RIDGE PORT NORTH 5TH ADDITION

WICHITA, SEDGWICK COUNTY, KANSAS

RE: SUB 2002-53 -- One-Step Final Plat of Ridge Port North Fifth Addition

CASE NUMBER: SUB 2002-53 -- RIDGE PORT NORTH FIFTH ADDITION

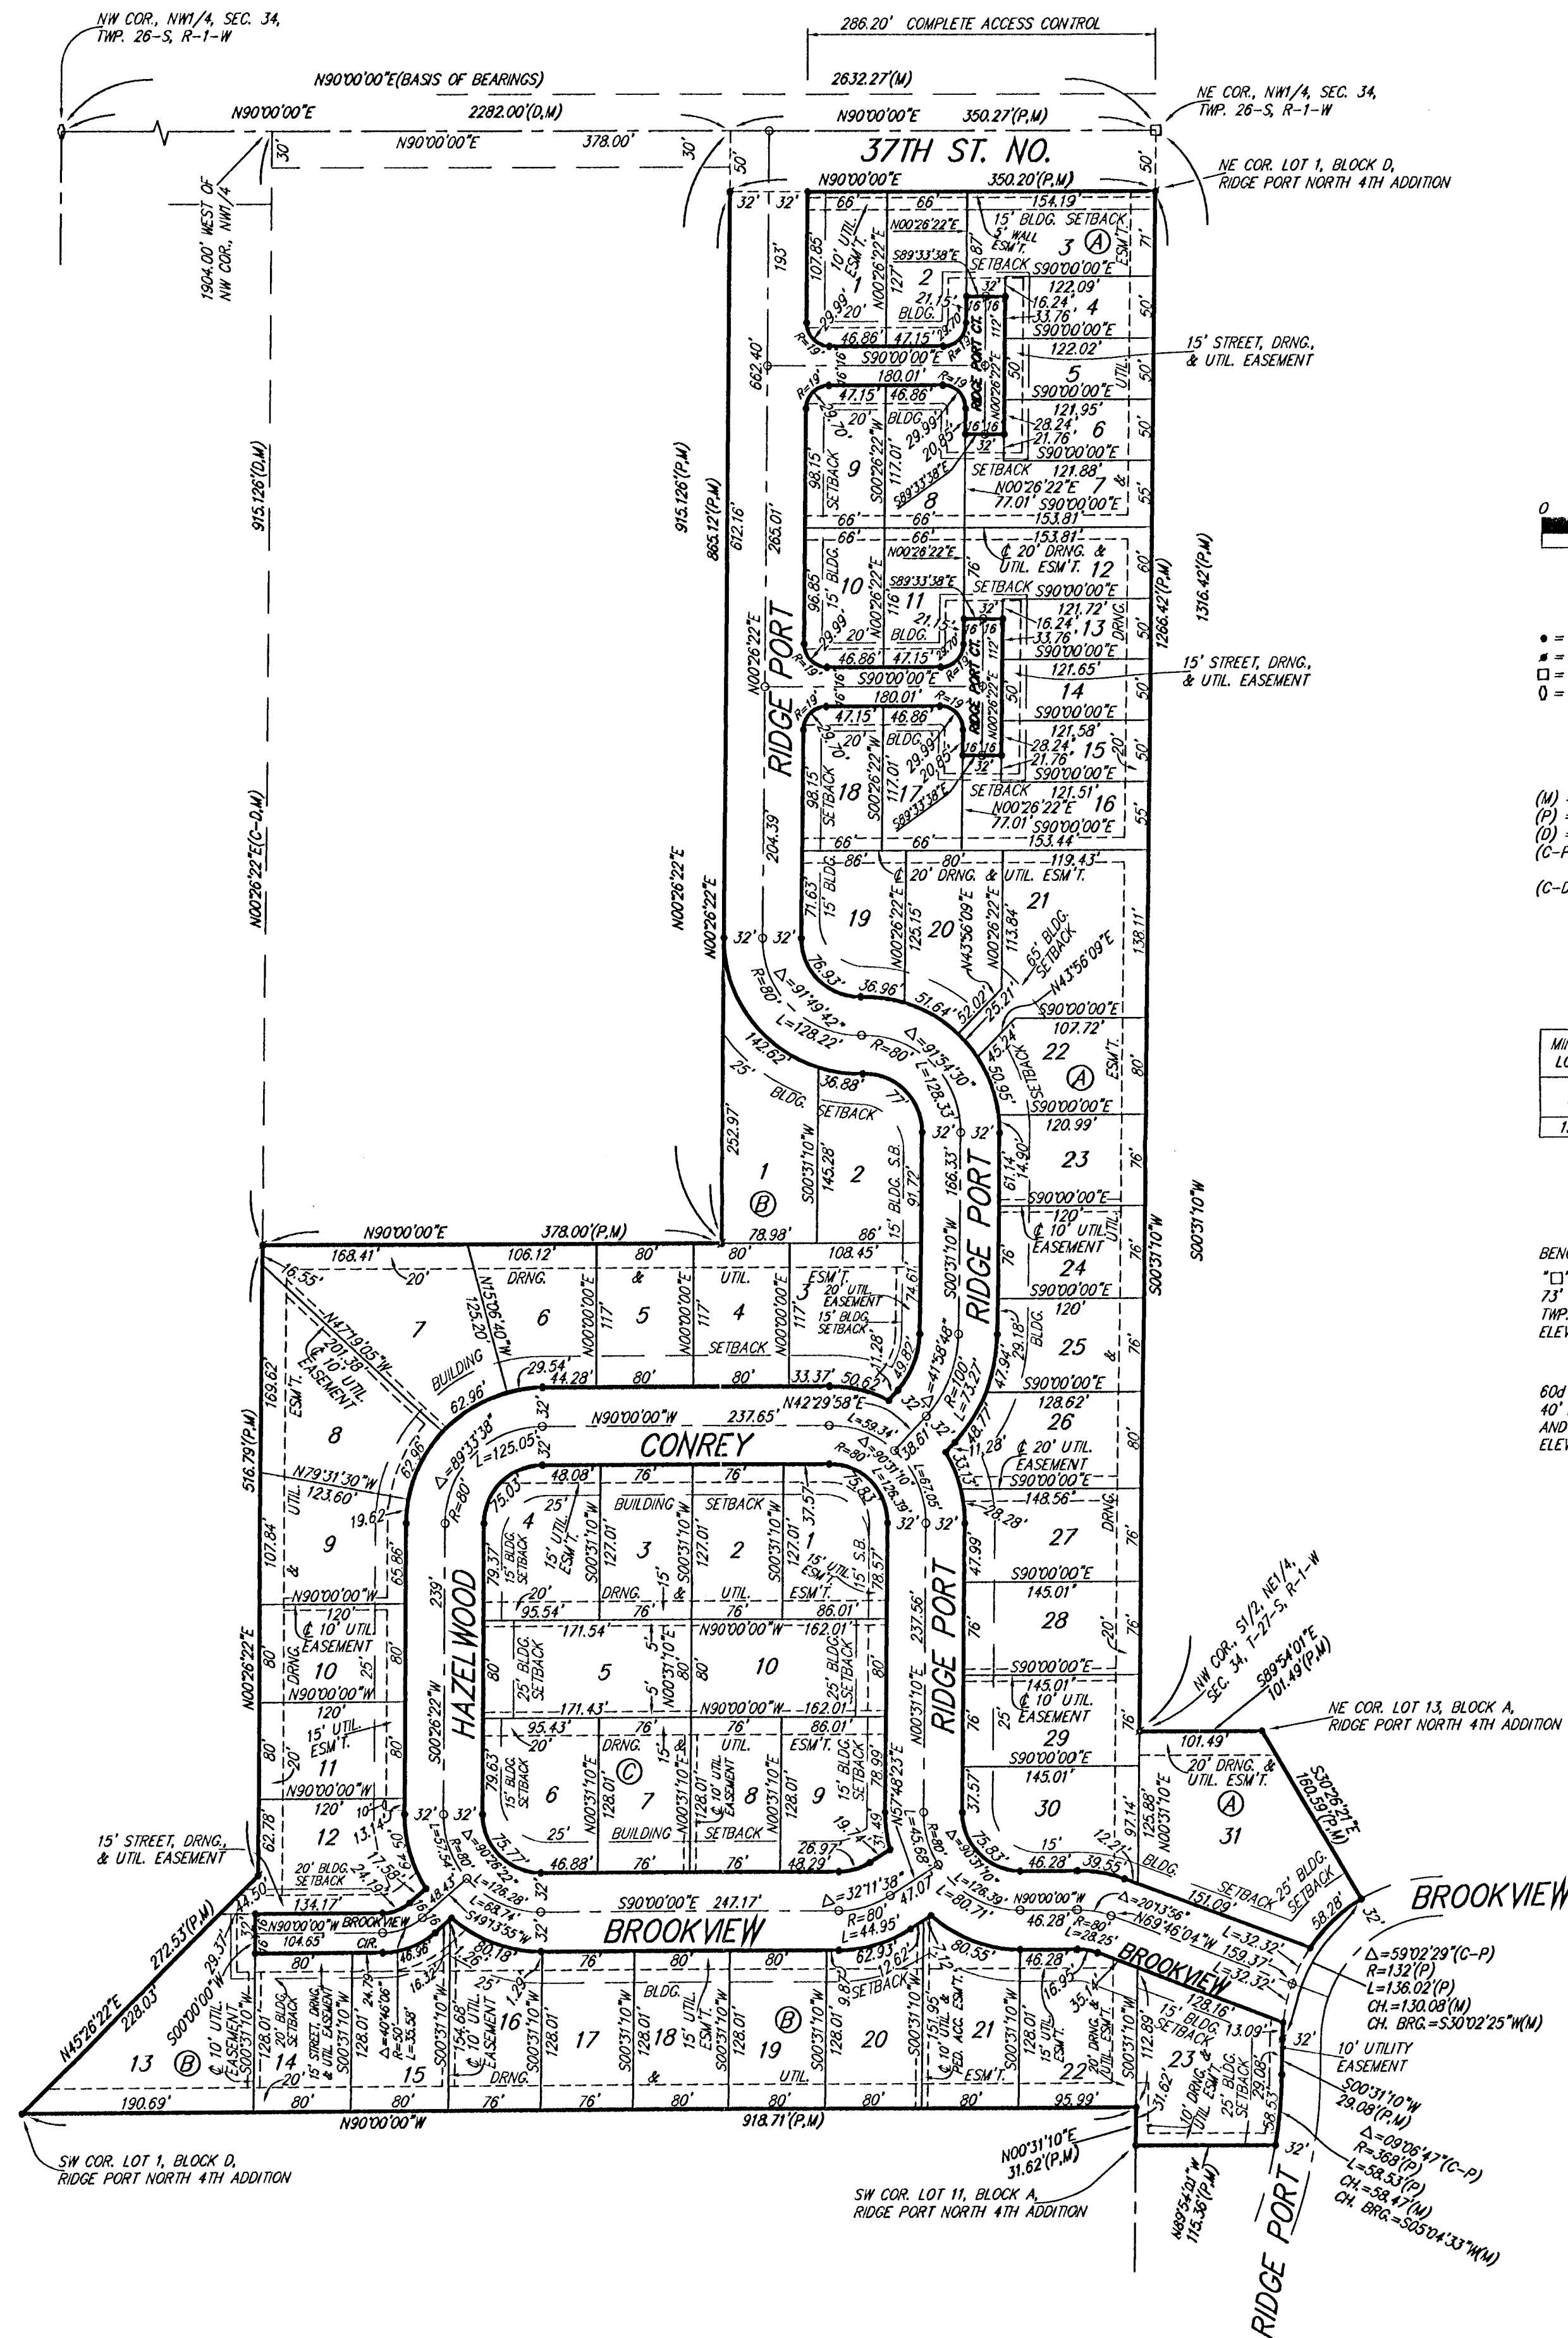
- A. The applicant shall guarantee the extension of sanitary sewer and City water to serve the lots being platted, including a water supply line along the frontage of 37th St. . City Engineering needs to comment on the need for other guarantees or easements. The required 15-ft street drainage and utility easements abutting the 32-ft streets need to be labeled.

- D. City Engineering needs to comment on the status of the applicant's drainage plan. County Engineering has requested a drainage plan for review.
- E. The applicant shall guarantee the paving of the proposed interior streets. For the narrow public 32-foot streets, this guarantee shall be for the 29-foot paving standard. The guarantee shall also provide for sidewalks on at least one side of all through, non cul-de-sac streets.

- H. City Fire Department needs to comment on the turnarounds platted for the 32-ft streets. The turnarounds are approved.
- I. City Fire Department/GIS needs to comment on the street names. 36th St. N. needs to be renamed. Brookview Ct shall be renamed as Brookview Cir.

- J. Since this plat proposes the platting of narrow street right-of-way with adjacent "15-foot street drainage and utility easements", a restrictive covenant shall be submitted which calls out restrictions for lot-owner use of these easements. Retaining walls and change of grade shall be prohibited within these easements as well as fences, earth berms and mass plantings.

- M. Lot 21, Block A does not conform with the 50-ft lot width standard which is measured at the building setback line. An increase in the distance of the building setback from the road would meet the standard.

- X. The representatives from the utility companies should be prepared to comment on the need for any additional utility easements to be platted on this property. Westar Energy requests additional easements.
